Northern Quartz Campus

Surface water assessment - BESS, Substation and Transmission line

E231133 RP1

ES3 Request for information response

Figure 5.1 Longitudinal section locations – Plan view

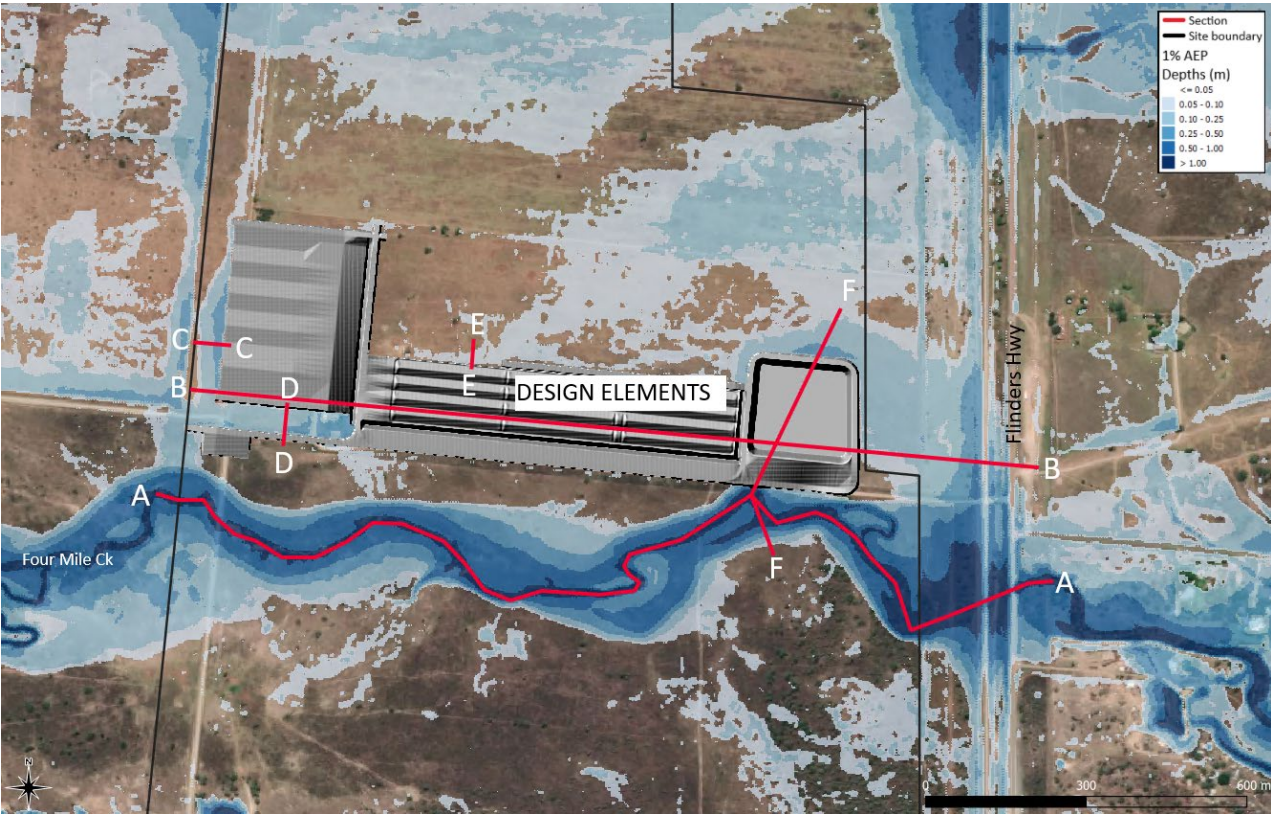
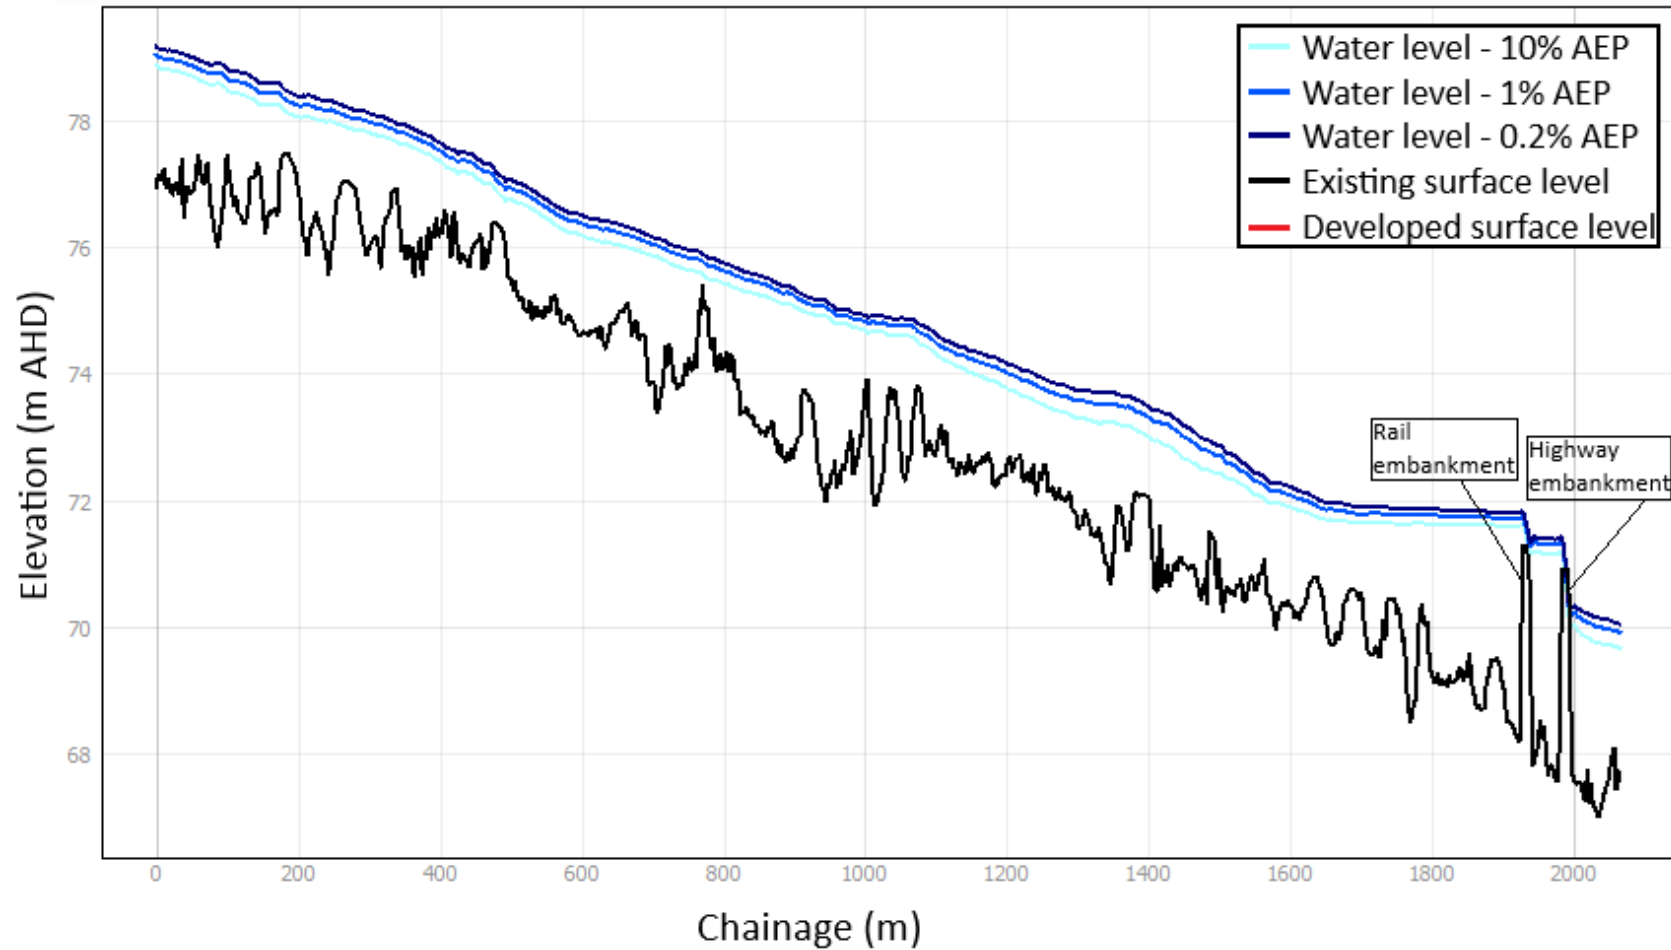
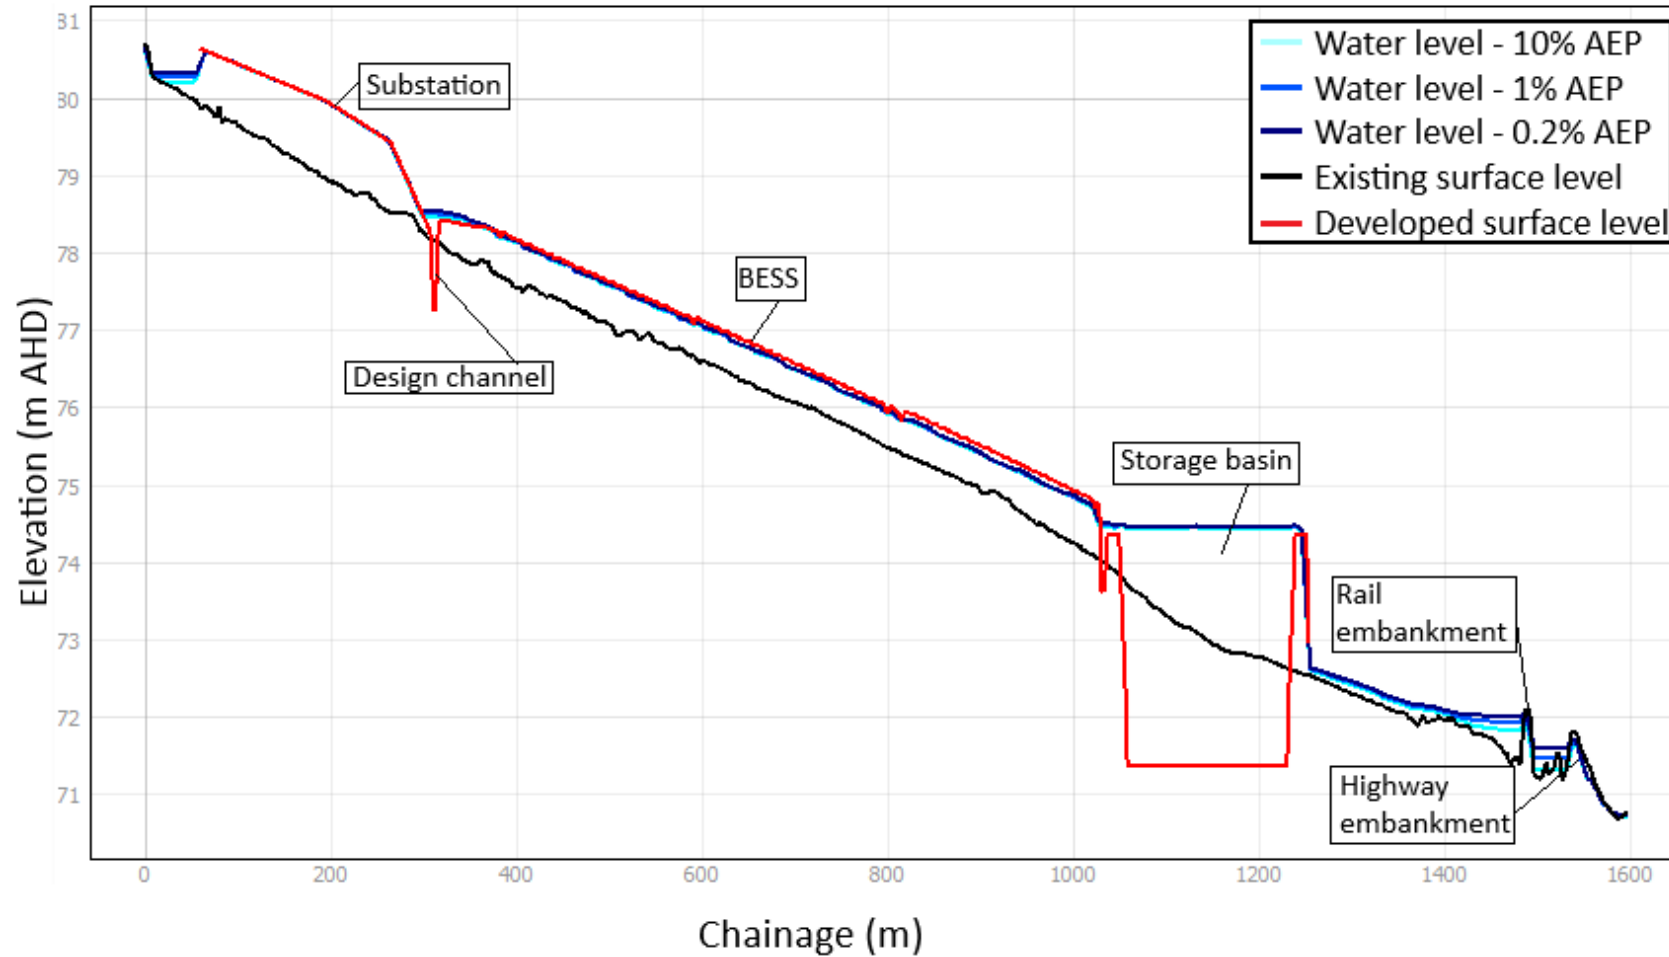
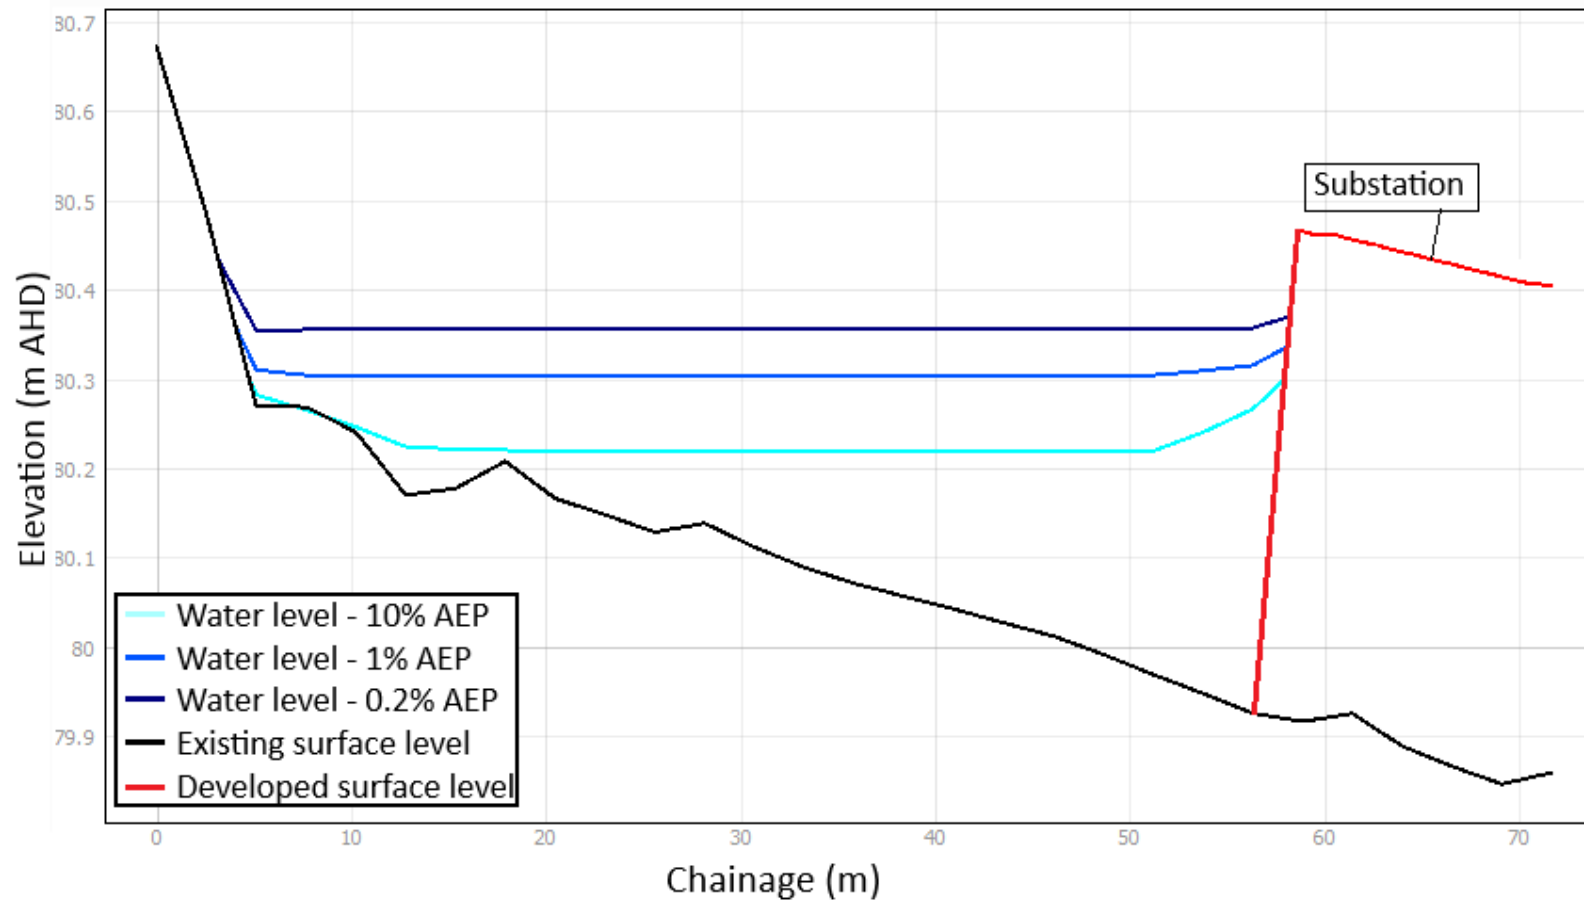
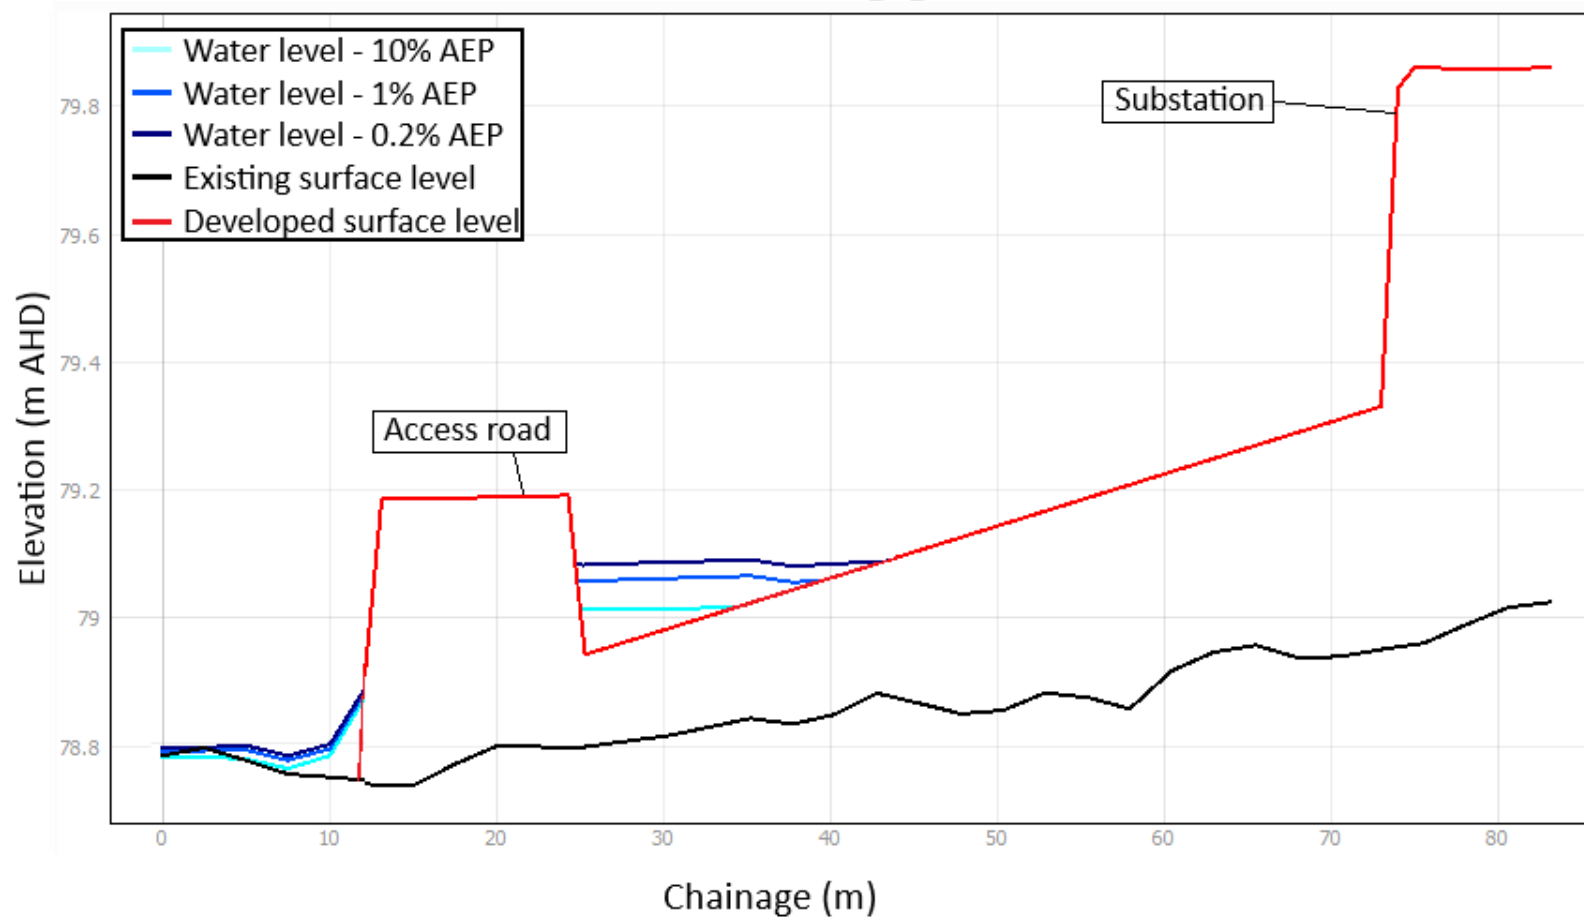
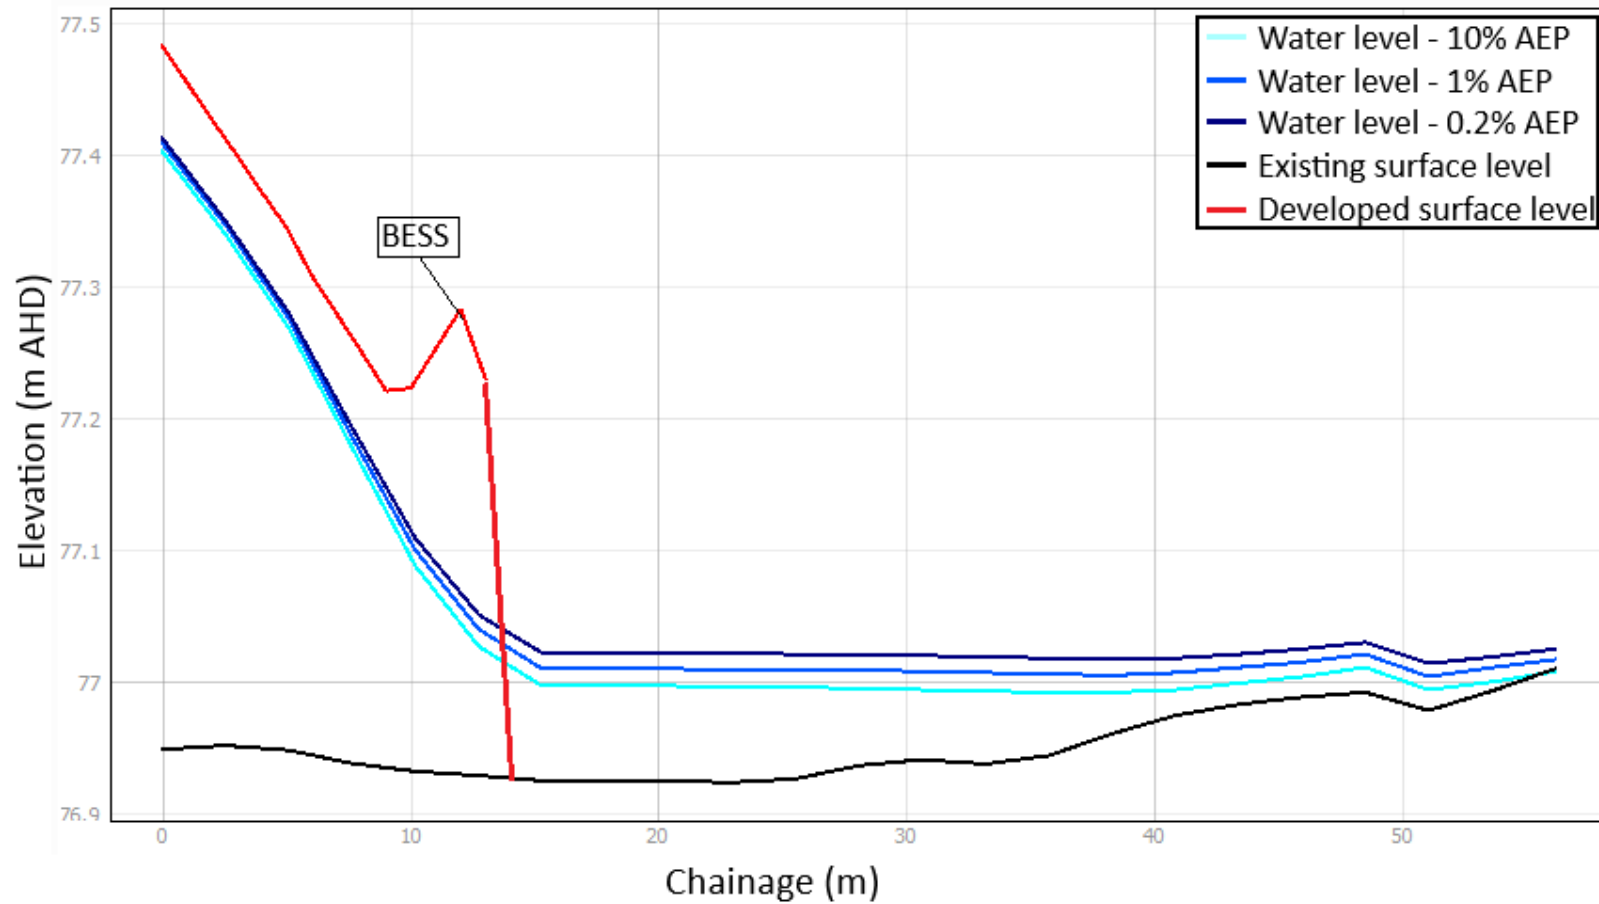
Detail	Response	Additional information reference
Sections are requested to be added to Figure 5.1. The submitted version shows blank plots.	Updated cross sections detailing the flood elevation levels against the existing and developed surface levels are provided in Section 5.4.1. The substation pad and BESS pad require elevation to meet their respective flood immunity requirements of 0.5% AEP and 0.2% AEP flood levels respectively. Figures 5.1 – 5.7 provide cross section elevations to show the flood immunity the development. These figures confirm the appropriate flood immunity of both the Substation Pad and the BESS Pad structures.	Refer Section 5.4.1
Flood report		
Peak water surface elevation plots are requested to be included in Appendix A, along with spot 1% AEP levels reported at key locations within and around the development.	Updated cross sections detailing the flood elevation levels against the existing and developed surface levels are provided in Section 5.4.1 of the Water Resources Assessment Report. Additional plots on the 1% AEP levels at key locations within and around the development have been provided within Section 5.4.2 of the Water Resources Assessment Report. This information is further analysed and presented in Attachment A Flood impact assessment.	Water Resources Assessment Report Section 5.4.2, and Attachment A Flood impact assessment report.

The development lies within the TCC 'medium flood hazard' area. The substation pad and BESS pad require elevation to meet their respective flood immunity requirements of 0.5% AEP and 0.2% AEP flood levels respectively. Figures Figure 5.1 – Figure 5.7 provide cross section elevations to show the flood immunity of each pad.

Flood level long section figures show design flood level matching the top of design structures. This is due to the rain-on-grid flood modelling approach. As such, flood immunity is indicated by flood levels adjacent to the structures rather than directly on top of them. On pad pit and pipe drainage has been proposed on these structures, as well as top of pad gradient to perimeter drainage features to manage surface catchment, this is subject to detailed design phase.
